## Application for Works Approval

<b>Works Approval Number</b>	W6584/2021/1
<b>Applicant</b>	GMA Garnet Pty Ltd
<b>ACN</b>	009 344 227
<b>File number</b>	DER2021/000422
<b>Premises</b>	Port Gregory Garnet Mine 1420 George Grey Drive Yallabatharra WA 6535  Legal description Mining tenements M70/856, M70/204, M70/259, M70/926, M70/927, M70/968, G70/171, M70/1330 and M70/1331 (excluding Lot 58 on Plan 65344)
<b>Date of report</b>	22 December 2021
<b>Decision</b>	Works approval granted

**Figure 2: Locations of the proposed groundwater monitoring bores**

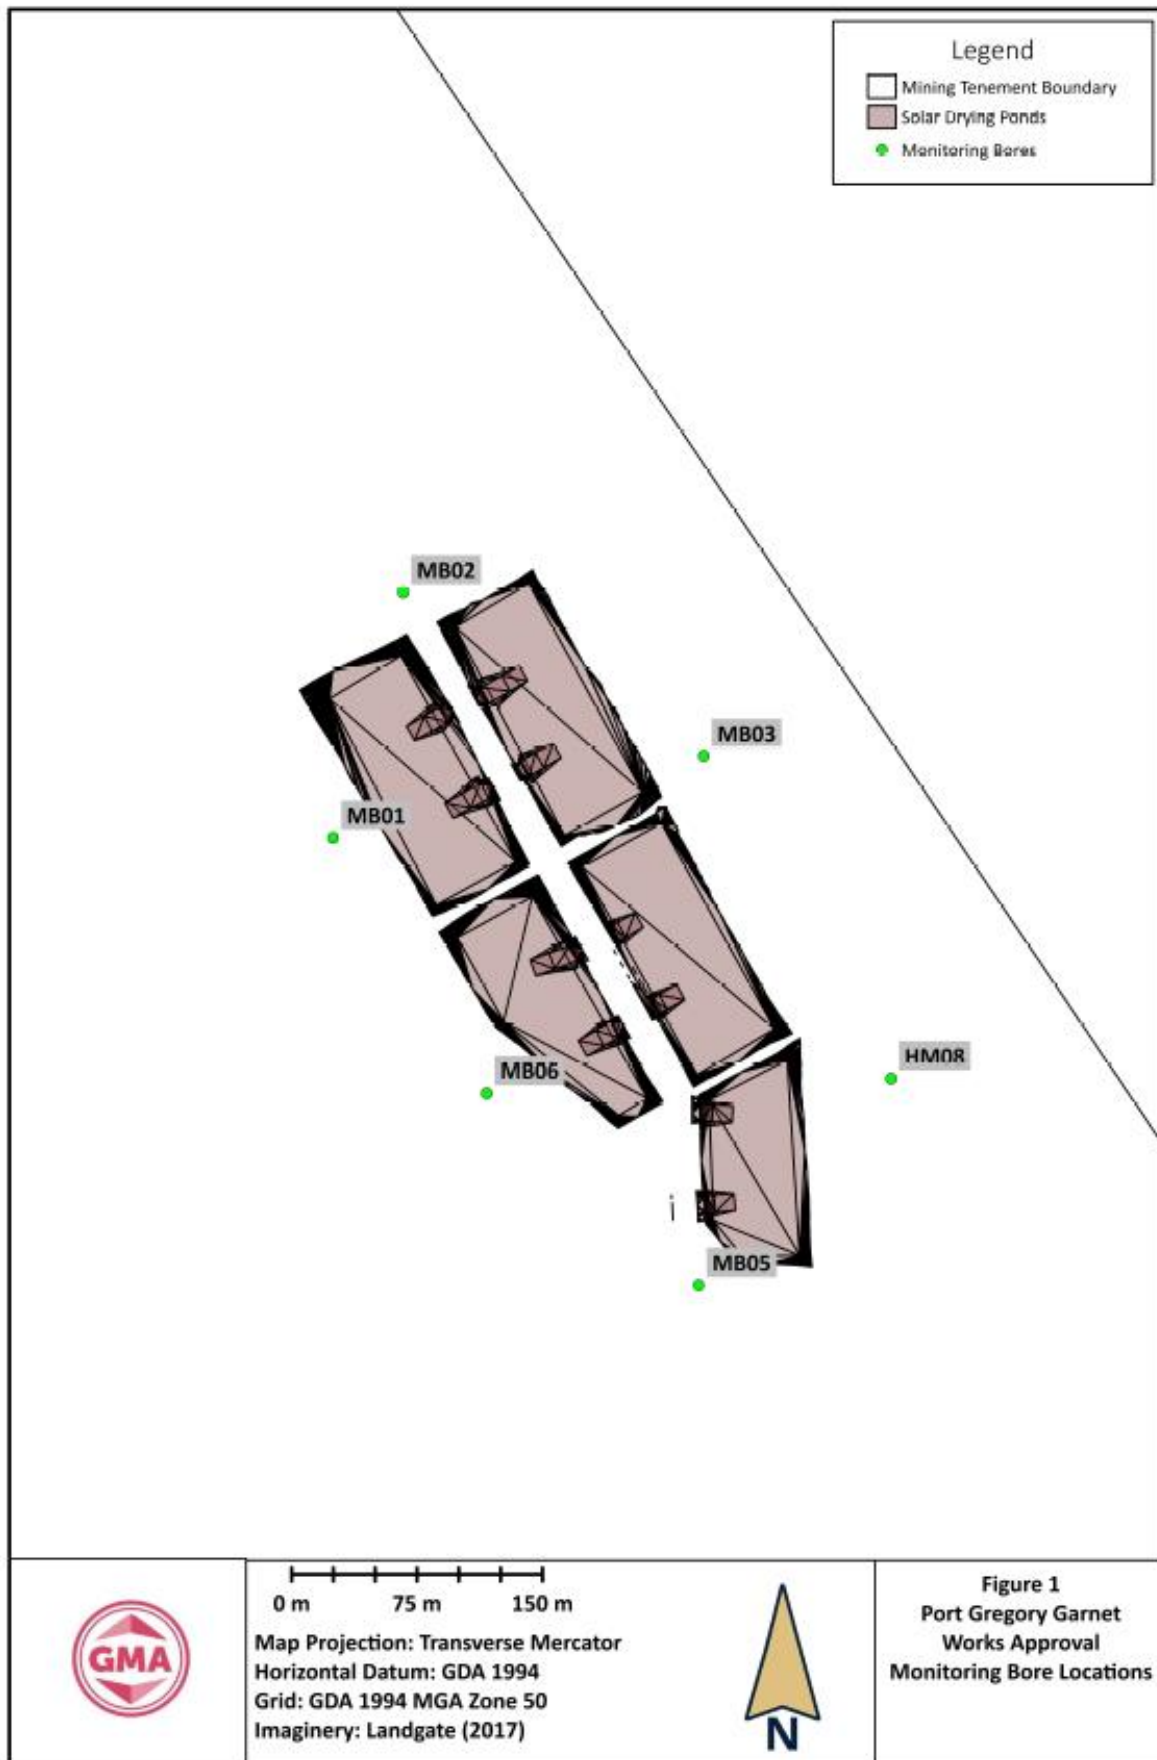
The applicant has proposed 5 new monitoring bores to be constructed around the solar drying pond to monitor the groundwater levels over time (Figure 2). A condition has been included in the works approval to require groundwater levels and quality monitoring at the above-mentioned monitoring bores proposed by the applicant. Additionally, it is required to conduct a baseline groundwater monitoring programme prior to commencement of time-limited operation. This will allow monitoring of any potential groundwater mounding impacts due to tailing seepage from the solar drying ponds overtime. Other proposed applicant controls to minimise seepage from the base of the ponds are summarised in section 3.1.1.

Condition	Summary of applicant's comment	Department's response
Condition 1, Table 1	<p>DWER requested design details of decant return system if the applicant planning to construct one as a part of this project.</p> <p>Applicant notified DWER that a decant return system will not be implemented as part of the project.</p>	N/A
Condition 2	<p>"Proposed monitoring bore 4 represents a background monitoring bore. The proposed bore is located approximately 60 metres north of the existing monitoring bore HM08 and upgradient east of Pond 4. GMA request the department to consider removing the requirements regarding the installation of monitoring bore 4. In addition, GMA proposes monitoring HM08 per the requirements detailed in Table 3 of the draft Works Approval."</p>	<p>DWER has considered the applicant's request to remove the requirement of constructing proposed monitoring bore 4 which is in the proximity of monitoring bore HM08.</p> <p>Given the close proximity of the two bores, the location of HM08 being upgradient of the solar drying ponds and the applicant's commitment to monitor the water in HM08 in accordance with the DWER requirements, DWER will remove the requirement to construct proposed monitoring bore 4.</p>

It has been determined that additional conditions will be added to the works approval requiring the proper installation of groundwater monitoring bores, baseline groundwater monitoring (water level and quality) prior to the start of time limited operations and continued monthly monitoring of groundwater levels and quality during time limited operations. A limit for standing water levels within the groundwater monitoring bores (4 mbgl) have also been added to the works approval to ensure groundwater mounding does not impact surface vegetation.
